Brewery Road Apartments, Stillorgan, Co.
Dublin

Stormwater Audit Stage 1

Document Number: 192-206-SWA-S1

DRAWN G.Byrne	DESIGNED EC	APPROVED JG	DATE APRIL '19
SCALE 1:250 @A1	JOB NO. 18-093	DRG. NO. P211	REVISION

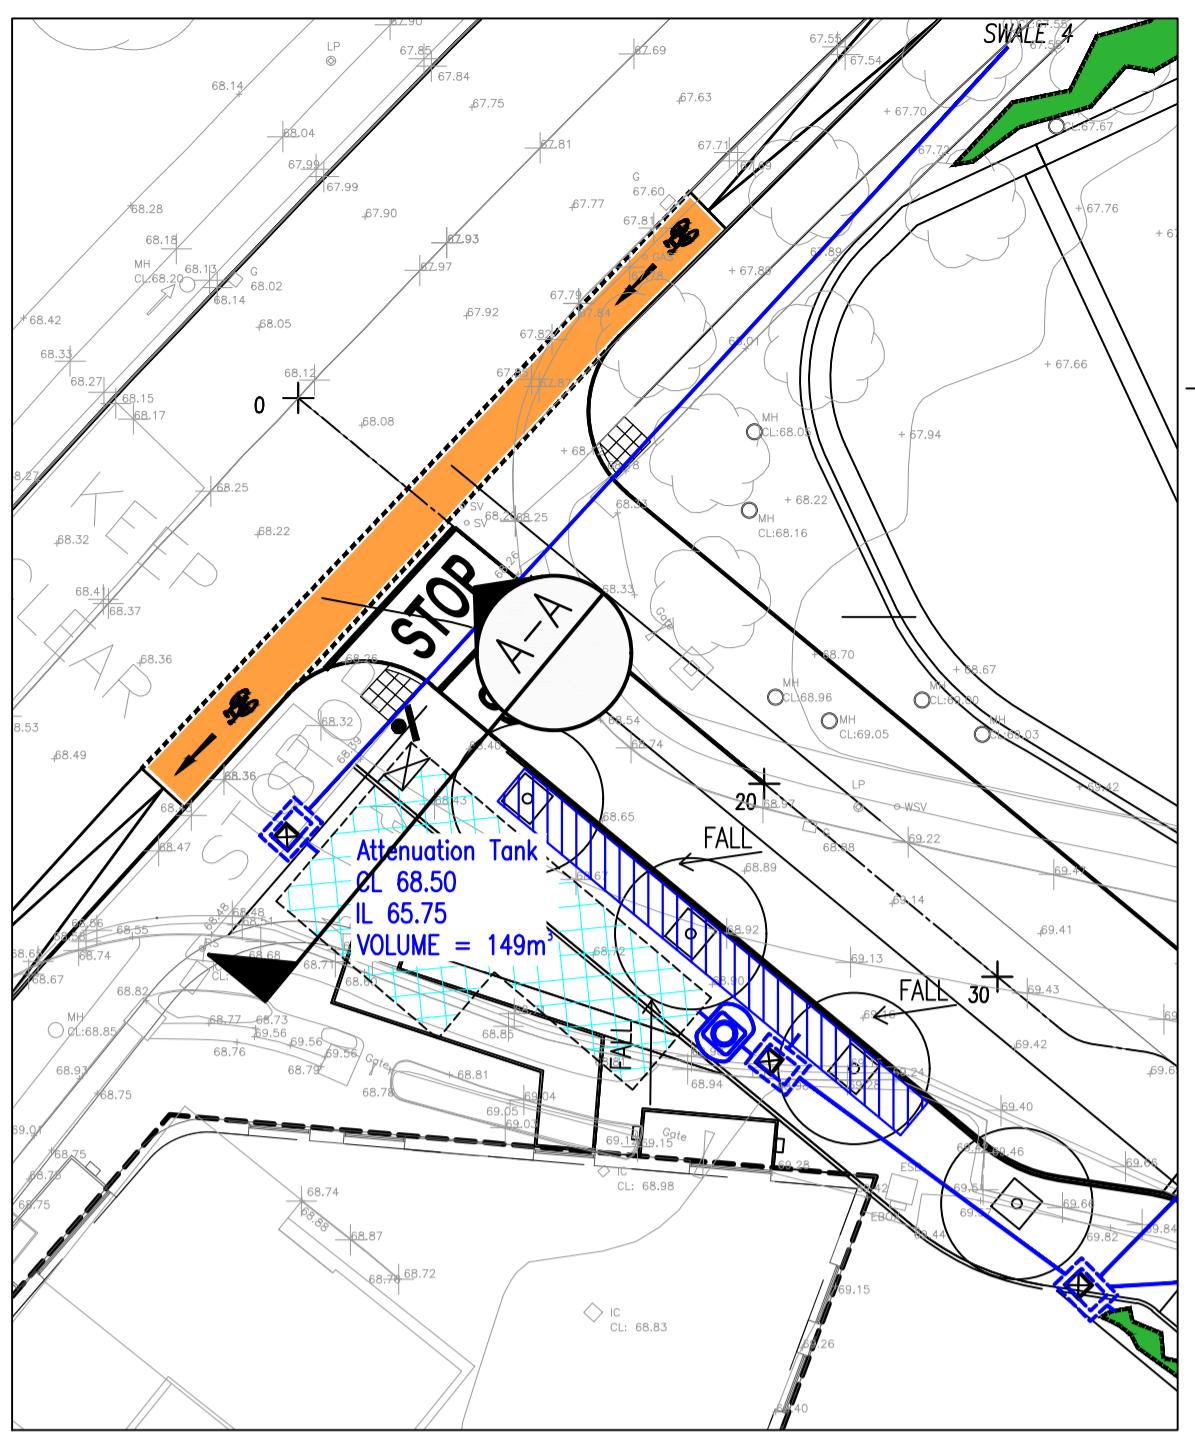
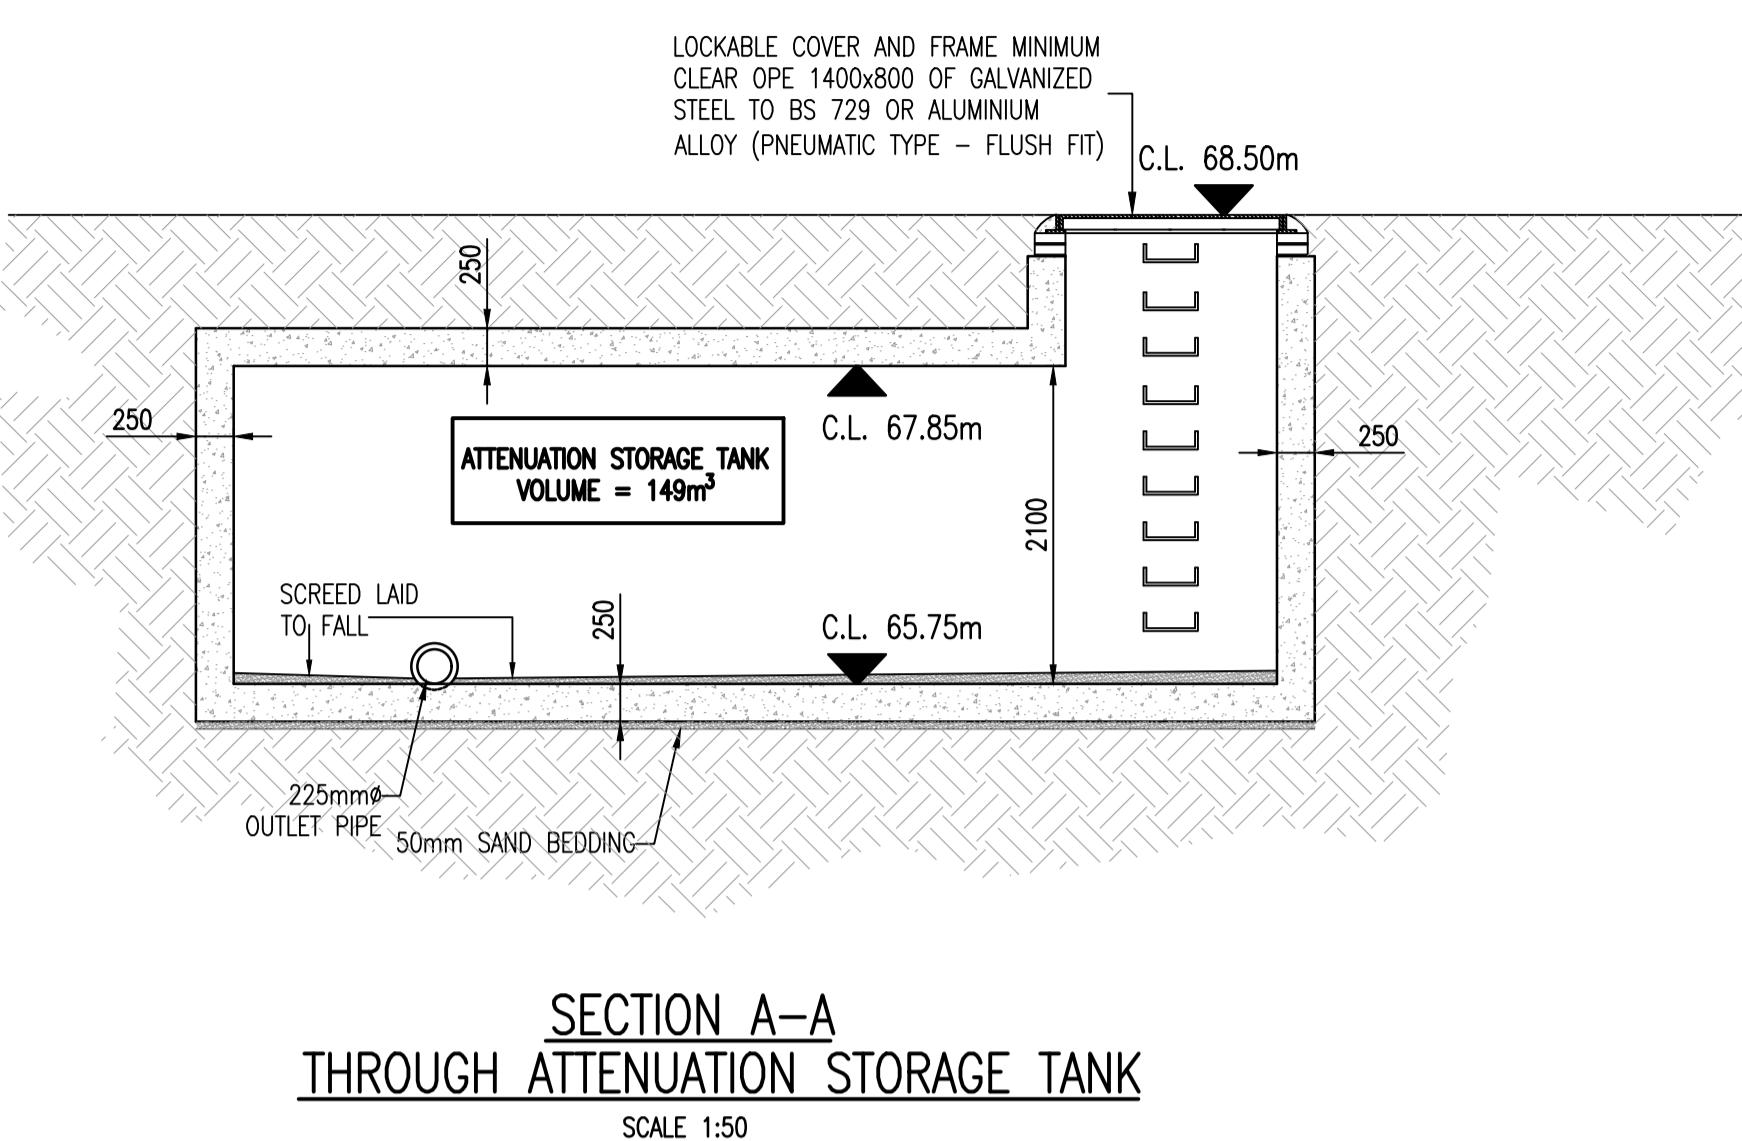
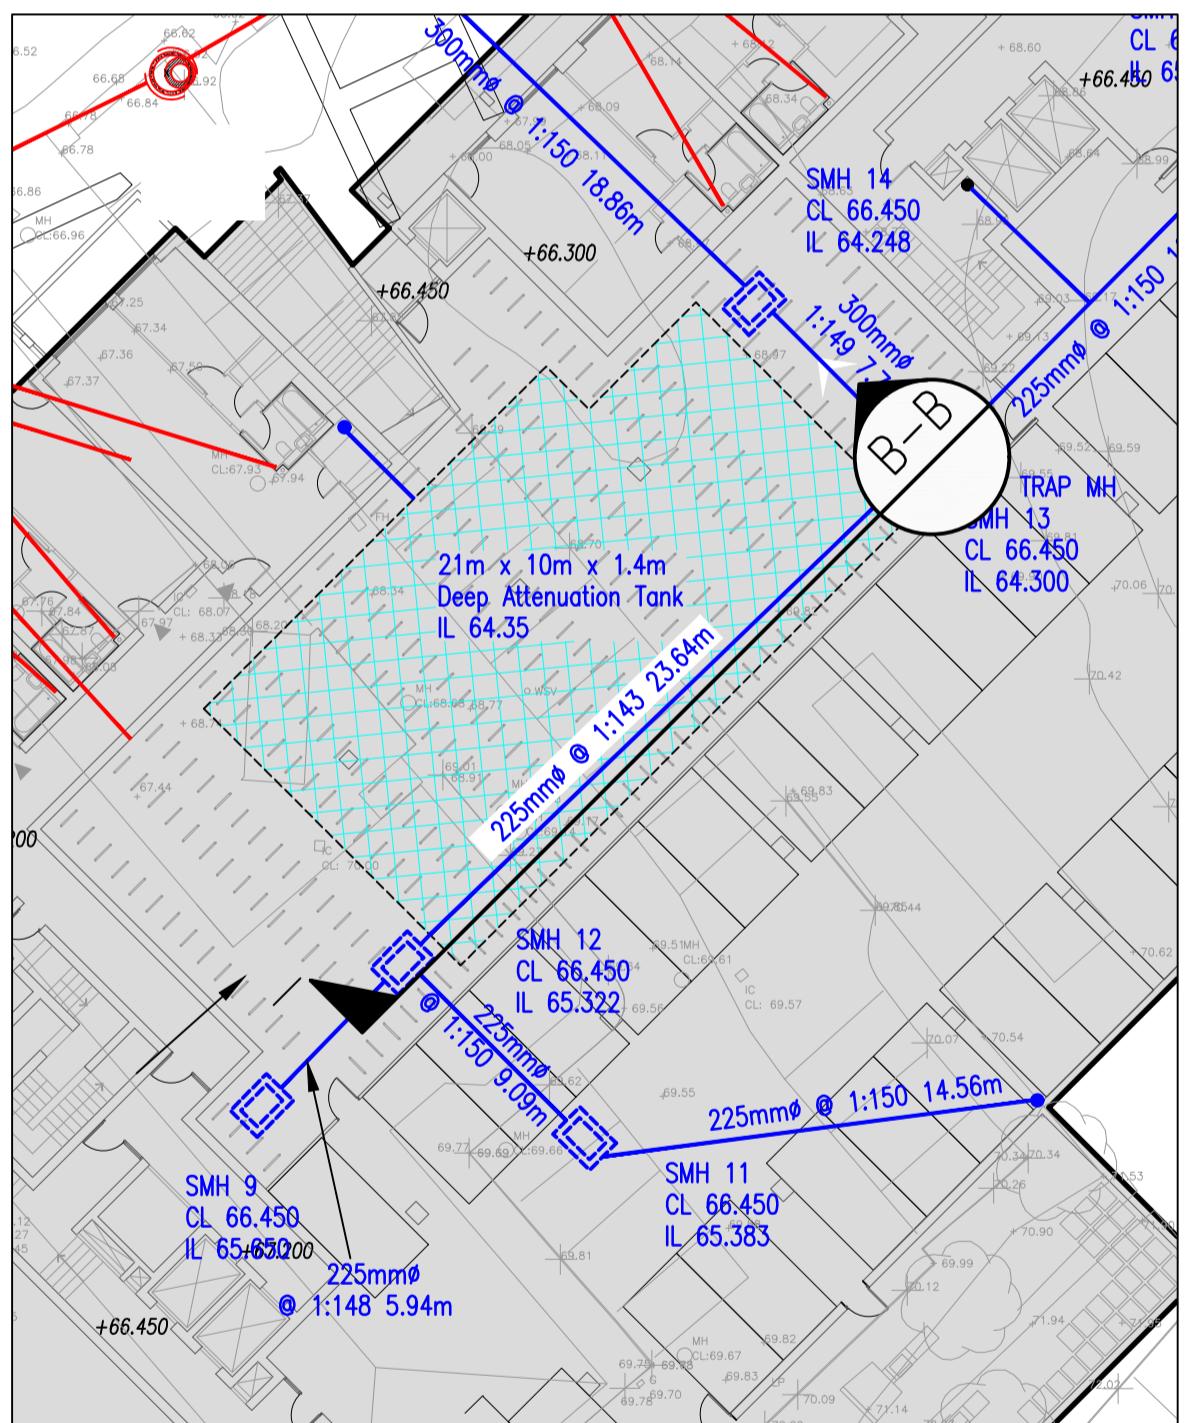
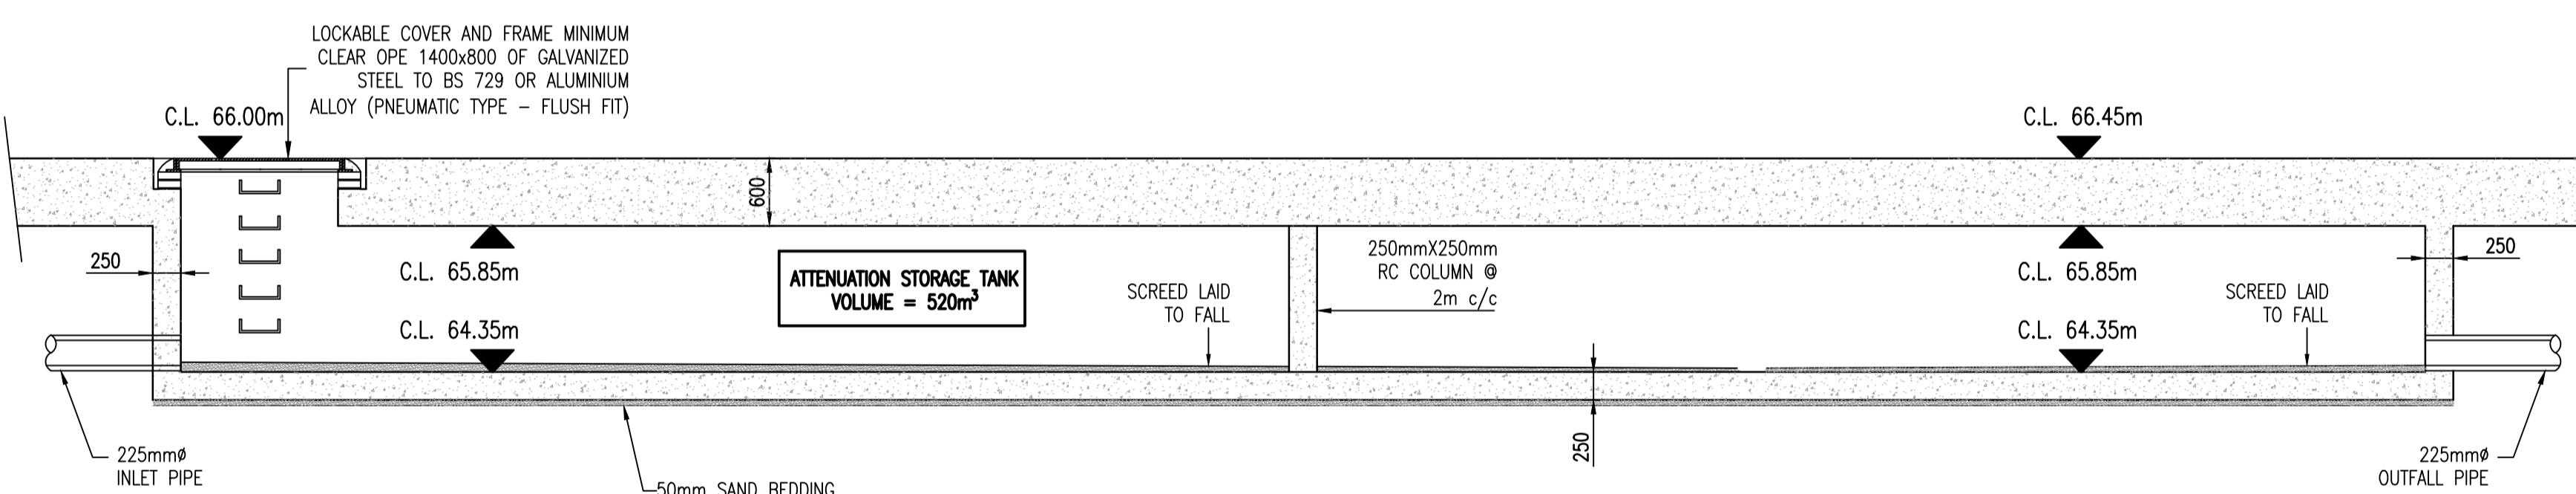
Problem: details of attenuation tank outside Block N not submitted.

Recommendation: Submit details of same

2.1.13	Y	Y	See details of tank outside Block N attached on drawing P211.	Yes
2.1.14	Y	Y	Access can be provided from the cycle parking area for general maintenance. If a large vehicle is required for pumping it can park on Brewery Road and provide a rising main through the ground floor access to the cycle store from Brewery Road.	Yes
